City of Portland, Oregon
Bureau of Development Services
Land Use Services
FROM CONCEPT TO CONSTRUCTION

REVISED STAFF REPORT AND RECOMMENDATION TO THE DESIGN COMMISSION

CASE FILE: LU 14-246259 DZM
PC # 14-184664
Couch 9
REVIEW BY: Design Commission
WHEN: April 16, 2015 @ 1:30 PM
WHERE: 1900 SW Fourth Ave., Room 2500A
Portland, OR 97201

ELEVATION SOUTH

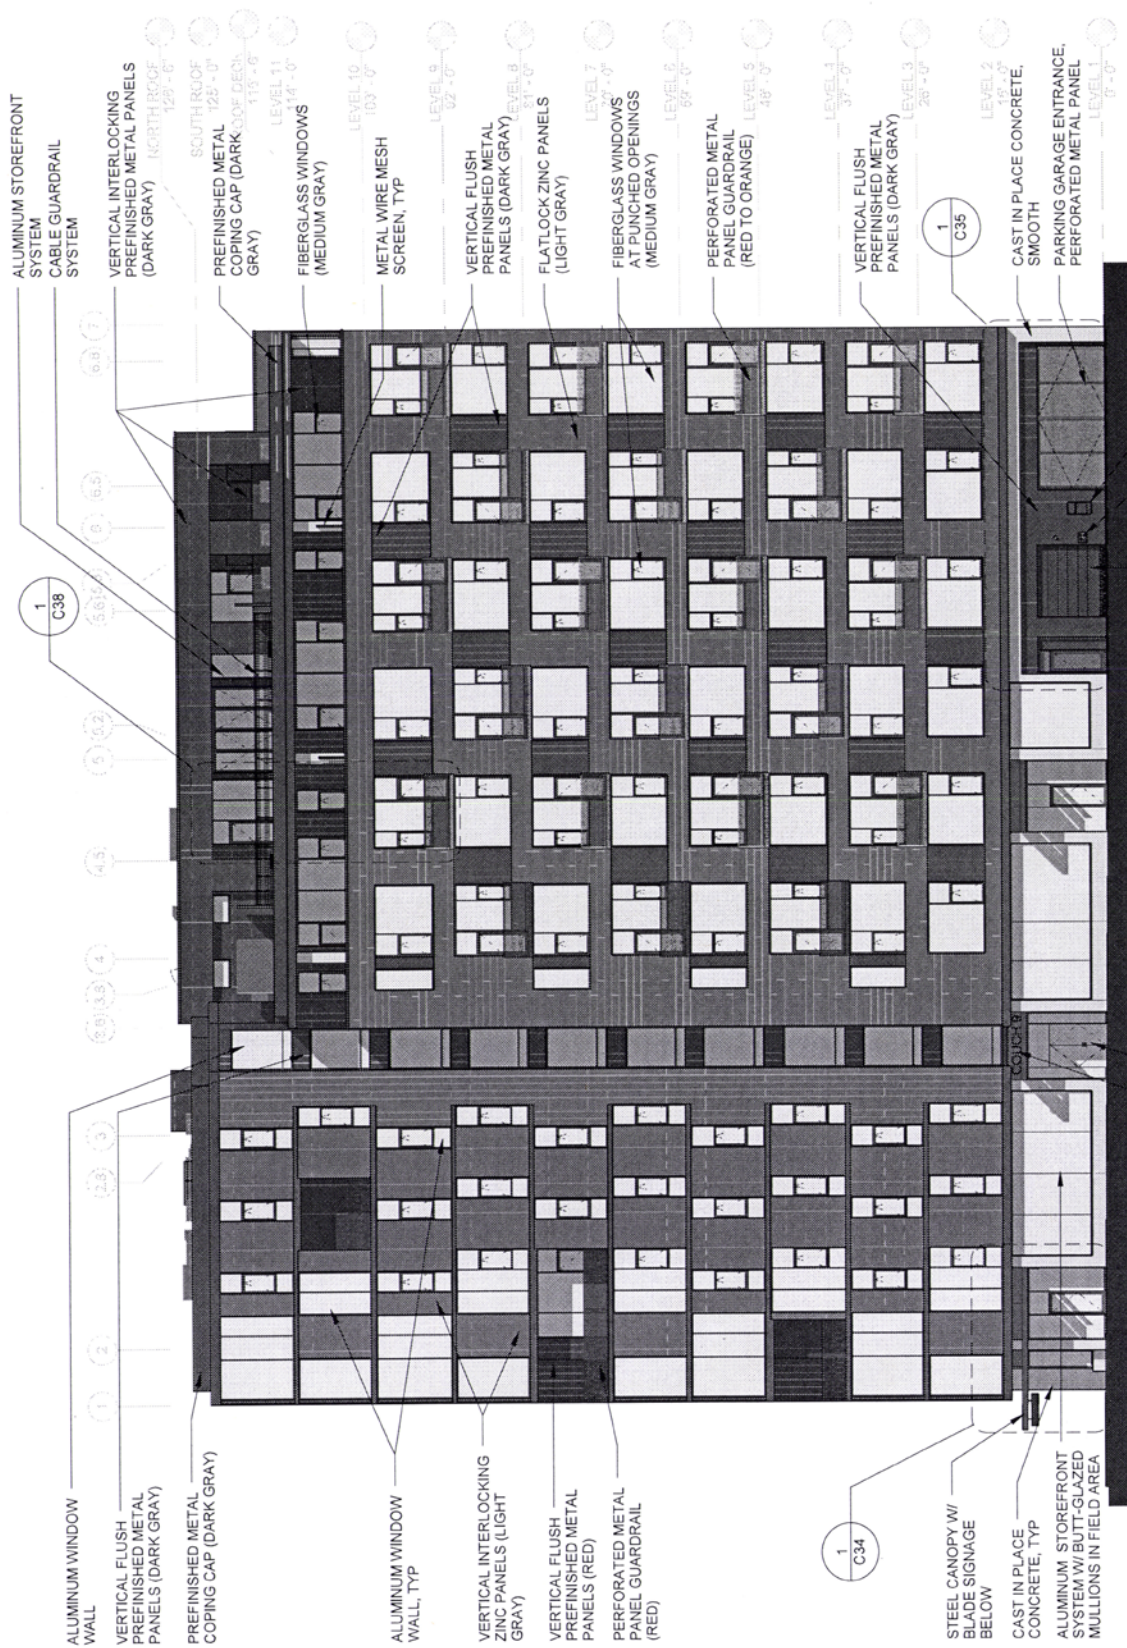
Findings: The building is oriented to the intersection at 9th Avenue and NW Couch Street. It presents a long transparent corner retail space and entry at the street-level. Above, the recessed balconies break down the mass of the building by eroding the corner, which adds visual interest to the intersection. A recessed storefront and entry at the corner creates a larger effective sidewalk area for public gathering. Ground floor retail will have an entrance, sign and marquee accentuating the corner. This guideline has been met. *This guideline has been met.*

C31
ELEVATION EAST

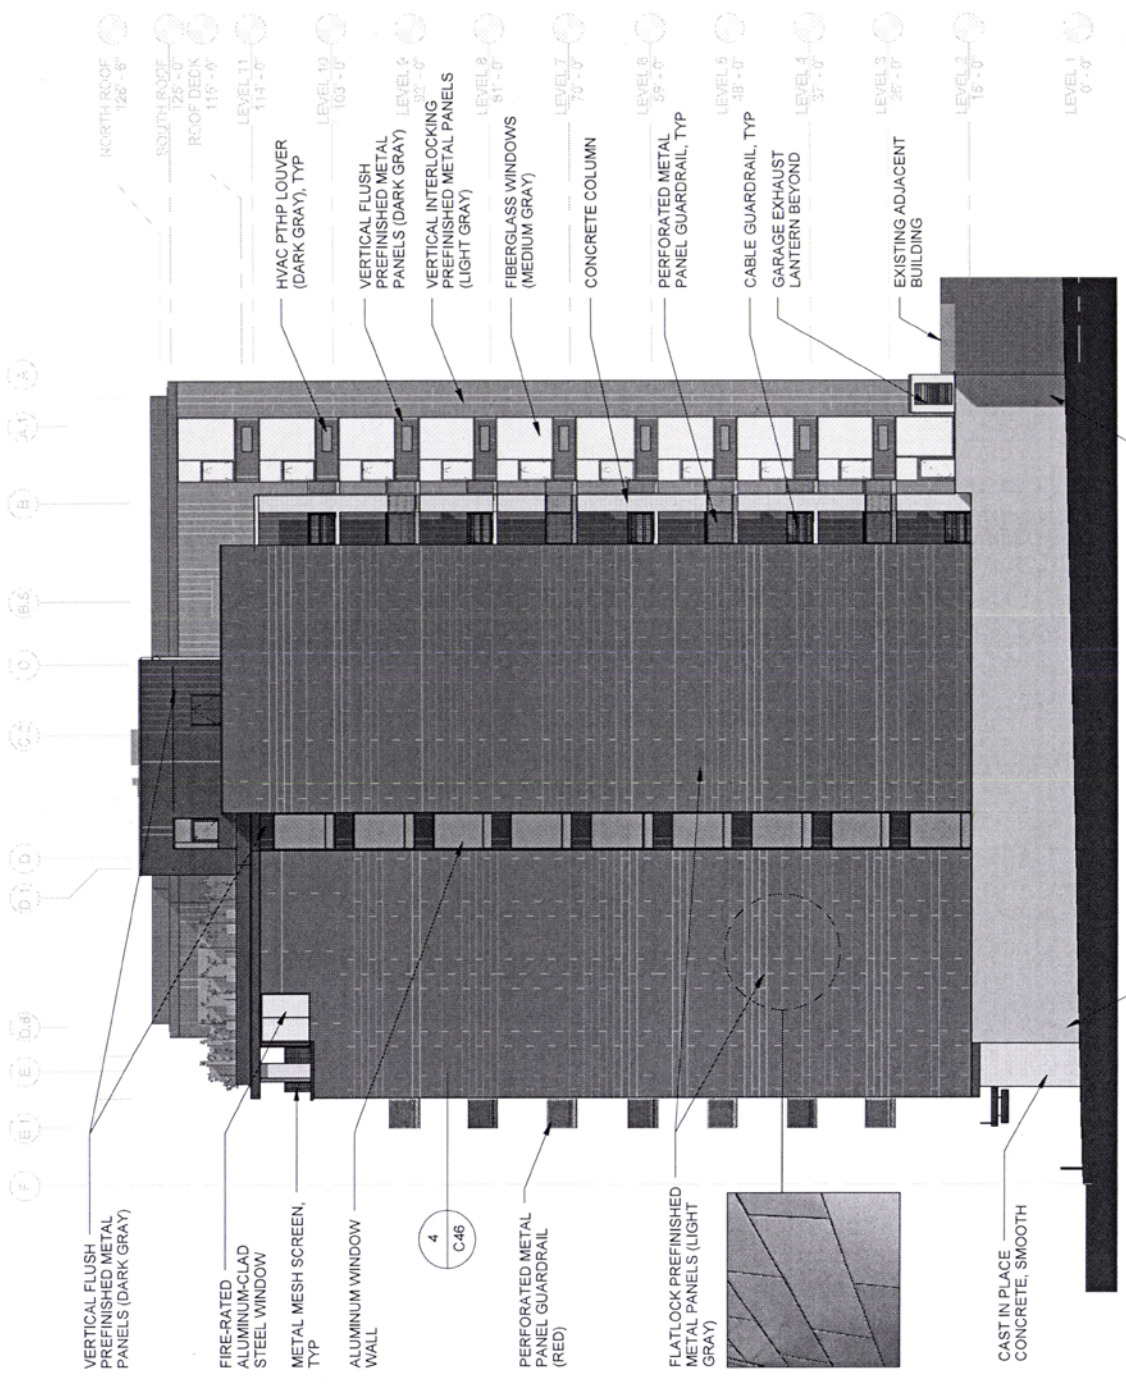
At the DAR, the Design Commission stated the western façade should more compelling and consistent with the composition of the south and east facades. At the hearing on March 19th, the applicant presented changes that eliminated the vertical sliding shade screens and incorporated colored horizontal guardrails, which is more consistent with the balcony expression on the rest of the facades. However, the Design Commission stated the composition was too complicated and more coherency was needed, particularly with the railings. These concerns with the west elevation were addressed as follows:

- False vertical columns were removed.

- Offsets of balconies were increased by 1' to provide more depth to the overall façade.
- Color of the concrete frame was rendered more accurately (darker gray) to quiet the frame element and better complement the color palette of the building.
- As suggested for a single railing language, the applicant explored all perforated railings in lieu of the cable rail, however, it was not preferred by the applicant as it appeared too monotonous and solid. Therefore, the alternating perforated railings and cable rails have been maintained for openness and contrast across the façade.

- The windows on the west end wall are more organized and now stacked with darker metal panels between the floor levels. This strengthens the vertical on this flush end wall creating more interest and articulation and better complements the end wall treatment on the north elevation.

- The windows on the west façade of the 11th floor clubroom have been modified and enlarged to better complement the proportions and styles of the windows on the other facades, as well as add functionality.
